DEVELOPMENT APPLICATION ASSESSMENT REPORT

Application Number:	DA2025/0176
----------------------------	-------------

Responsible Officer:	Anaiis Sarkissian
Land to be developed (Address):	Lot 41 DP 6746, 1100 Barrenjoey Road PALM BEACH NSW 2108
Proposed Development:	Alterations and additions to a dwelling house
Zoning:	C4 Environmental Living
Development Permissible:	Yes
Existing Use Rights:	No
Consent Authority:	Northern Beaches Council
Land and Environment Court Action:	No
Applicant:	JJ Drafting Australia Pty Ltd

Figure 2: *Proposed floor plan*

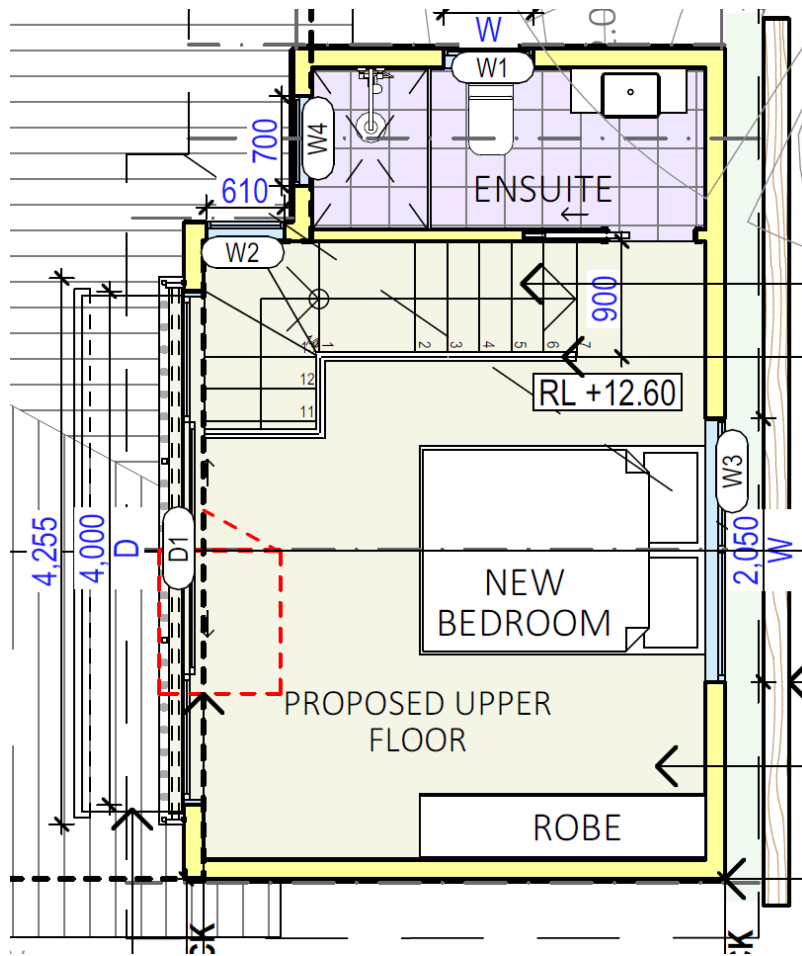
The submission raised concerns that the placement of the proposed balcony so close to the boundary, the elevation, significant rear placement of the proposed addition and clearance of vegetation will result in direct overlooking into the only outdoor area of the adjoining property to the south, severely affecting the neighbour's ability to enjoy their home without intrusion (refer Figure 1).

No windows are proposed to the southern elevation of the addition, and the proposed balcony is a Juliet balcony, meaning there is simply a balustrade connection to the building façade without a deck to step out on (refer Figures 2 and 3). As such, the Juliet balcony does not extend the trafficable area beyond the building's exterior wall, thereby limiting opportunity for overlooking towards the south and south-west. The proposed addition is also for a bedroom, which is a low-use room that would more likely be utilised in the evenings and early mornings, and not in the middle of the day when the neighbouring private open space area would more frequently be enjoyed.

Figure 6: 9am shadow

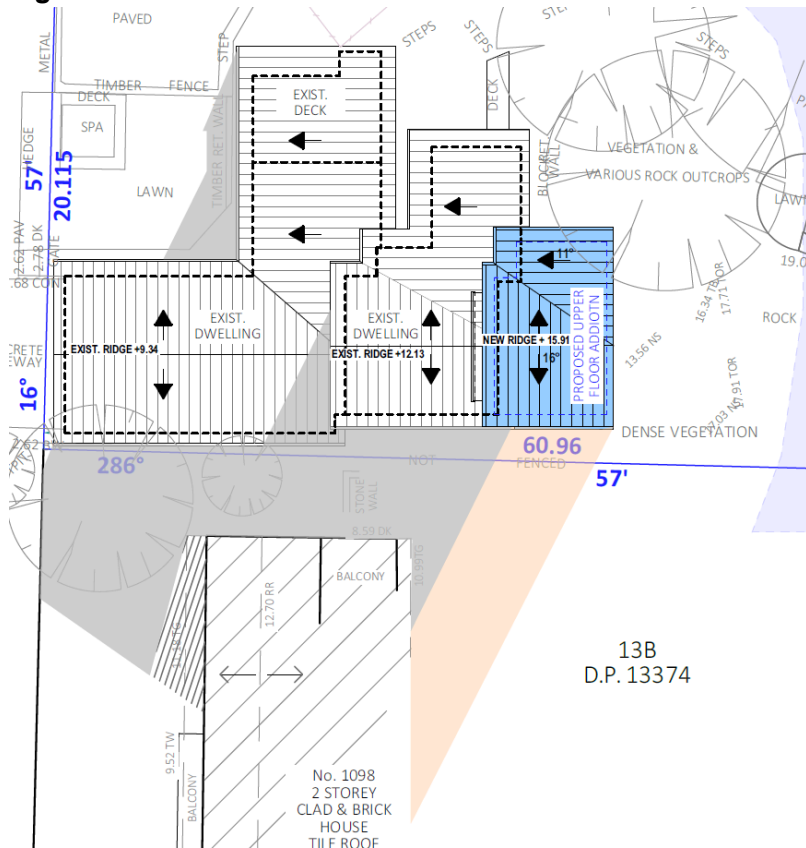
The submission raised concerns that the proposed development will cast substantial shadows over the adjoining property to the south, particularly on the outdoor deck area. This reduction in natural sunlight will not only make the space less usable but will also contribute to increased dampness and potential increased issues with mould and mildew. The objectors therefore anticipate a higher level of ongoing maintenance and associated costs.

The proposal overshadows the adjoining outdoor entertaining area in the early morning during Winter; however by midday, there is no additional overshadowing of the dwelling or private open space area for the rest of the day, as evident from the orange shading in Figures 6-8 below. Section C1.4 of the Pittwater 21 Development Control Plan requires the main private open space of any adjoining dwellings to receive a minimum of 3 hours of sunlight between 9am and 3pm on June 21st. The main private open space area to the southern adjoining property will continue to receive more than 3 hours of sunlight between 9am and 3pm on June 21st.
